SERVICE LETTER

No. 755C

Piper Aircraft Corporation

SUBJECT: Landing Gear Lock Actuator Rod and Rod End Bearing Inspection/Replacement.

SKETCH A

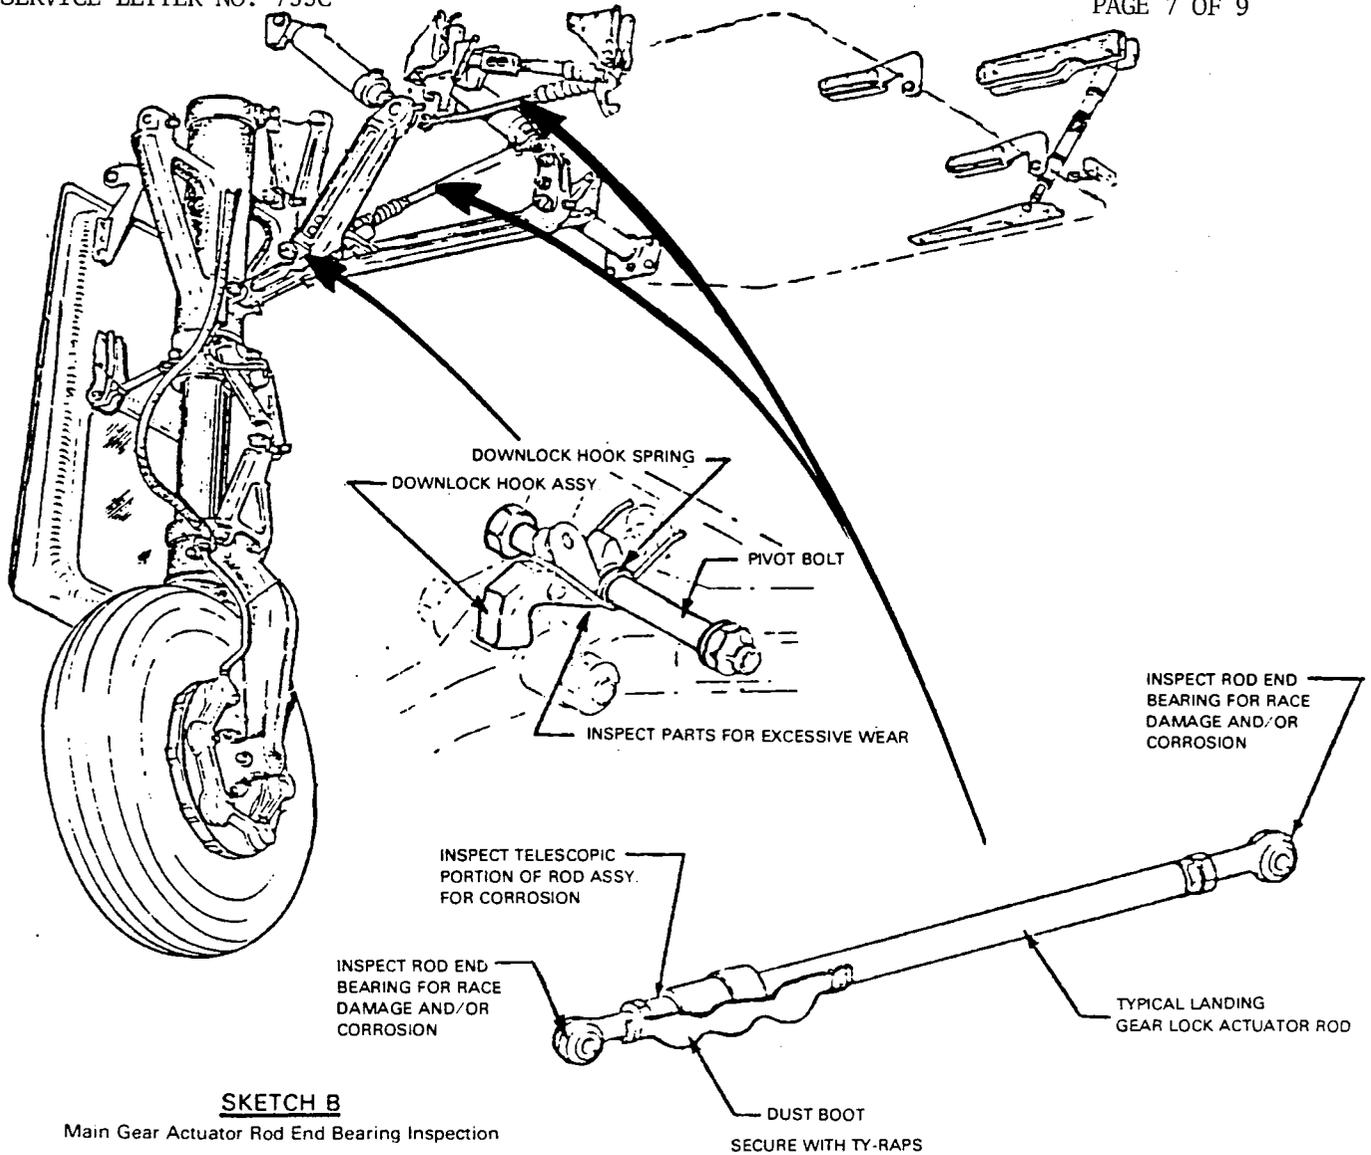
1. Locate and remove the nose gear lock actuator rod assembly from aircraft as shown.
2. Loosen the clamp attaching the dust boot to the landing gear lock actuator rod. Slide the dust boot back to expose the telescopic portion of the actuator rod assembly.

3. Inspect the telescopic portion of the landing gear lock actuator rod for evidence of corrosion.
 - a. If corrosion is evident, the landing gear lock actuator rod assembly should be replaced.

- b. If no corrosion exists, lubricate the telescopic portion with MIL-G-81322, 81827 or MIL-G-21164C lubricant.
4. Reposition and secure dust boot on each landing gear lock actuating rod assembly.

5. Inspect each rod end bearing for evidence of race damage and/or corrosion.
 - a. If corrosion is evident and/or ball and race of bearing shows evidence of damage (ball must rotate freely in race), it will be necessary to replace that bearing.

- b. If existing bearings show no evidence of corrosion or damage, lubricate bearings with MIL-L-7870 lubricant.
6. If a new main gear lock actuator rod assembly (assemblies) is being installed, lubricate the telescopic portion as described in 3b above, and the rod end bearings with MIL-L-7870 lubricant. Install existing dust boot on actuator rod assembly as shown.

7. Reinstall the nose gear actuator rod assembly on aircraft. Check system function and rigging; adjust as necessary using the appropriate Navajo Service Manual. Refer to Sketch "C" for the correct method of adjusting rod end bearings.

SKETCH B

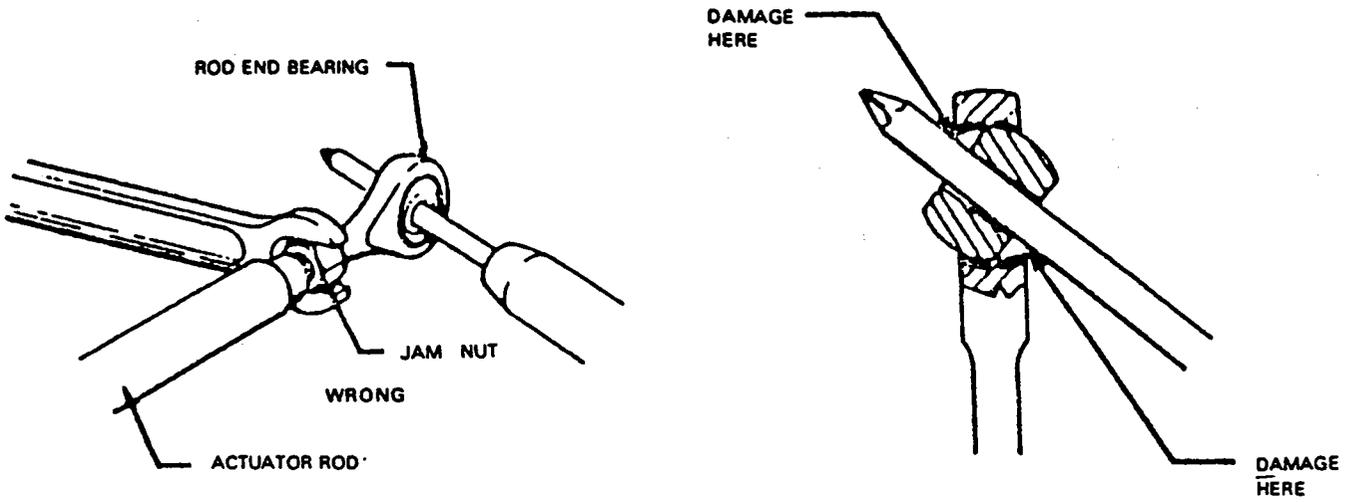
1. Locate and remove the main gear lock actuator rod assemblies from aircraft as shown. Accomplish on left and right main gear assemblies.
2. Loosen the clamp attaching the dust boot to the landing gear lock actuator rod assembly. Slide the dust boot back to expose the telescopic portion of the actuator rod assembly.

3. Inspect the telescopic portion of each landing gear lock actuator rod assembly for evidence of corrosion.
 - a. If corrosion is evident, the landing gear lock actuator rod assembly should be replaced.

- b. If no corrosion exists, lubricate the telescopic portion with MIL-G-81322, 81827 or MIL-G-21164C lubricant.
4. Reposition and secure the dust boot on each landing gear lock actuating rod assembly.

5. Inspect each rod end bearing for evidence of race damage and/or corrosion.
 - a. If corrosion is evident and/or ball and race of bearing shows evidence of damage (ball must rotate freely in race), it will be necessary to replace that bearing.

- b. If existing bearings show no evidence of corrosion or damage, lubricate bearings with MIL-L-7870 lubricant.
6. If a new main gear lock actuator rod assembly (assemblies) is being installed, lubricate the telescopic portion as described in 3b above, and the rod end bearings with MIL-L-7870 lubricant. Install existing dust boot on actuator rod assembly as shown.

7. Remove the main gear downlock hook assembly. Thoroughly clean the downlock hook assembly, downlock hook spring and pivot bolt and inspect each part for evidence of excessive wear. If any part or parts show excessive wear, those parts should be replaced.

8. Reinstall the downlock hook assembly, spring and pivot bolt on aircraft. Lubricate pivot bolt and hook with MIL-G-81322, 81827 or MIL-G-21164C Lubricant.

9. Reinstall the main gear lock actuator rod assemblies on aircraft. Check system function and rigging; adjust as necessary using the appropriate Navajo Service Manual. Refer to Sketch "C" for the correct method of adjusting rod end bearings.

SKETCH C

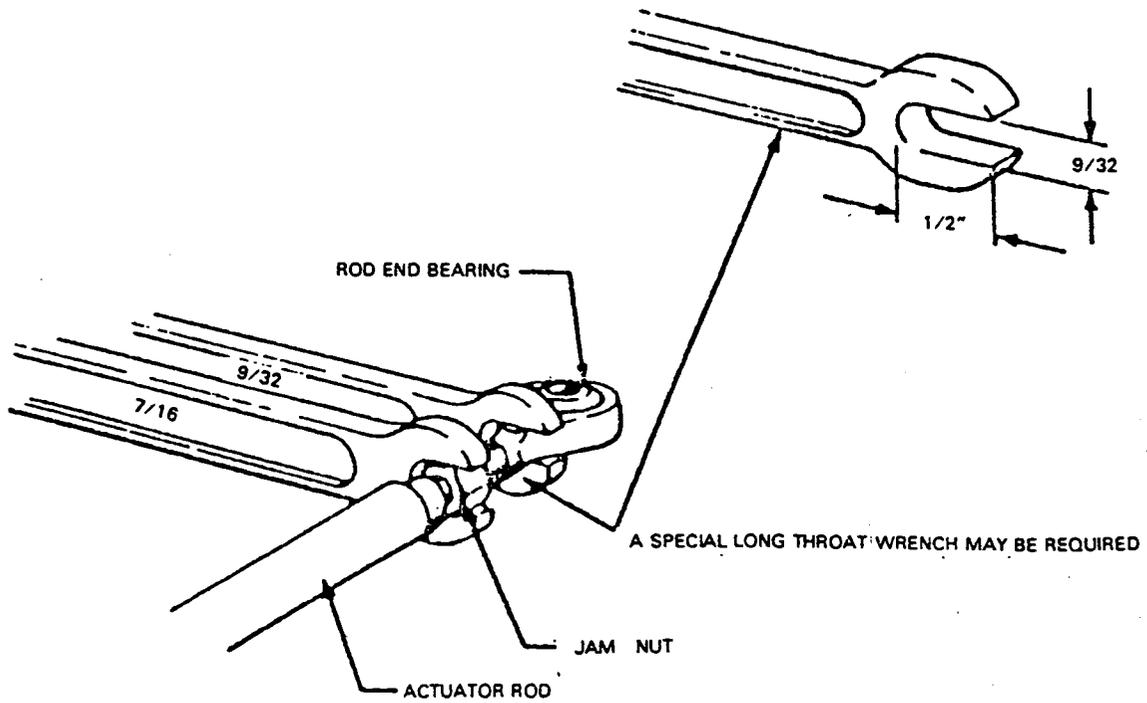
NOTE: It has been found that rod end bearings race damage - incurred during maintenance/rigging activity - has resulted in landing gear system difficulties and/or premature rod end bearing replacements. This Service Release also provides a recommended method for backholding the bearing assembly while adjusting the adjacent jam nut to prevent bearing race damage (refer to attached instruction data for details).

IMPROPER METHOD OF ADJUSTING ROD END BEARINGS
(RESULTING IN LOCKED BALL)

CORRECT METHOD OF ADJUSTING ROD END BEARINGS

SKETCH D

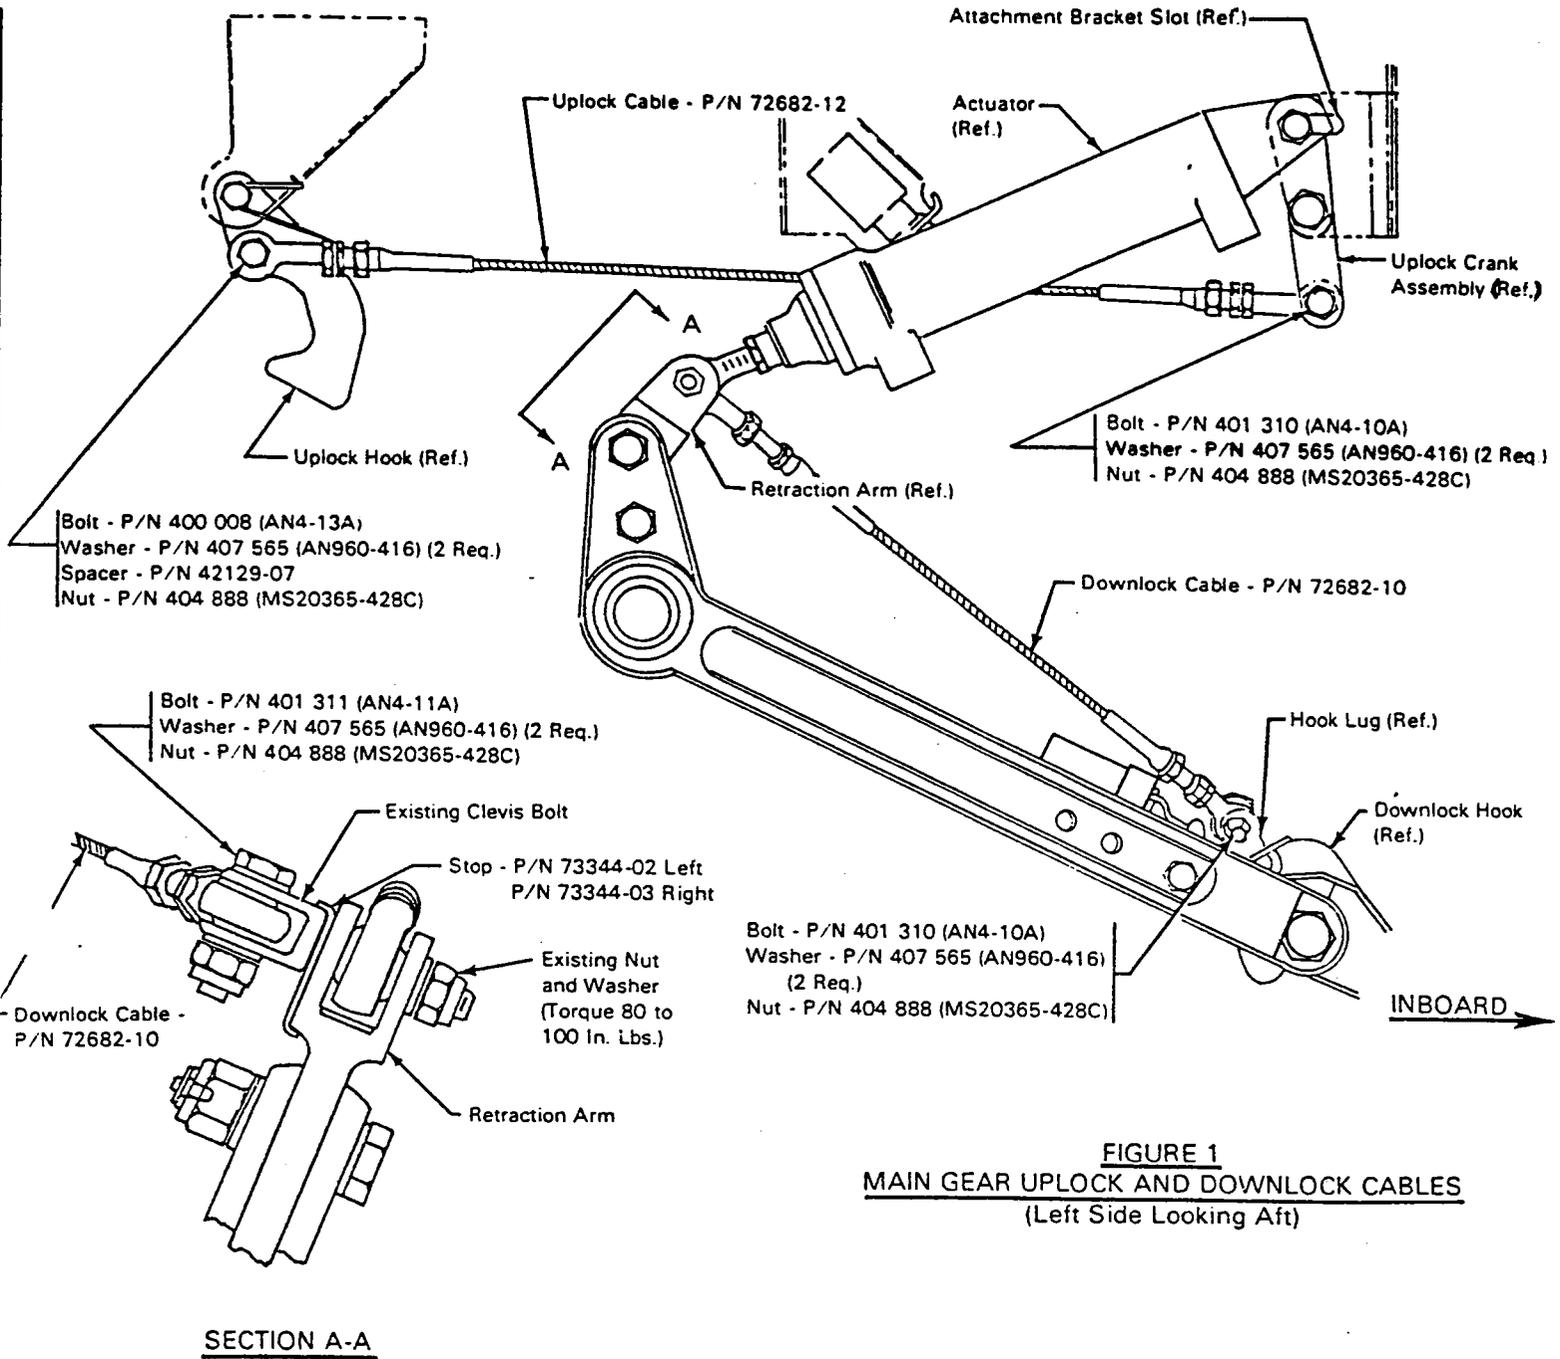
PURPOSE: Above affected models and serial numbers of aircraft were delivered with the new landing gear uplock and downlock cable assemblies. Installation of these stops between the retraction arm and clevis bolt will prevent possible rotation of the downlock cables and insure safe gear indications.

NOTE: Refer to Sketch D, Section A-A of this Service Letter for anti-rotation stop installation.

1. Remove nut and washer from the clevis bolt (fork) connecting the down-lock cable to the retraction arm.
2. Pull out the clevis bolt and install Stop, Piper Part Number 73344-02 (left side) and 73344-03 (right side) over the bolt and reinsert bolt through the retraction arm.
3. Install washer and nut and torque 80 to 100 inch pounds.
4. Repeat procedure on the opposite gear.
5. Make proper logbook entry of compliance with PART III of this Service Letter.
